Description: Loud Speaker 300/600W External

Service Manual: ASM-LS Service Bulletin No.: ASM-LS-603-0004

ECO No.: ECO1190 Subject: Re-entrant tip securing inspection (Loctite® LRUs, MOD 3)

Figure 3: Breaking and removal of the locking tab

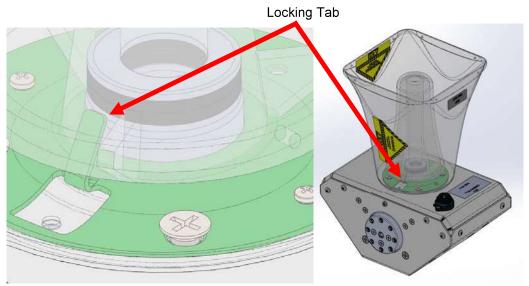
- 2.1.3.1 If the periodic inspection has failed, then all proceeding steps are applicable.
- 2.1.3.2 Using WA-001 and a ½" drive wrench, apply sufficient counterclockwise force to loosen the re-entrant tip. The locking tab will break and become loose material. Remove the reentrant tip.

- 2.1.3.3 Remove and discard the broken locking tab from the previous step.
- 2.1.3.4 Apply Loctite® 242 to the re-entrant tip threads following all Loctite® application procedures.
- **Note:** Loctite[®] 242 sets in ten minutes and cures in 24 hours.
- 2.1.3.5 Reinstall the re-entrant tip less than 3 minutes after applying the Loctite[®] 242 to avoid the setting time. Tighten with the WA-001 to a torque of 100 in-lb using the torque wrench.
- 2.1.3.6 Remove the WA-001 and repeat all applicable steps in Section 2 Procedure Instructions for each re-entrant tip.
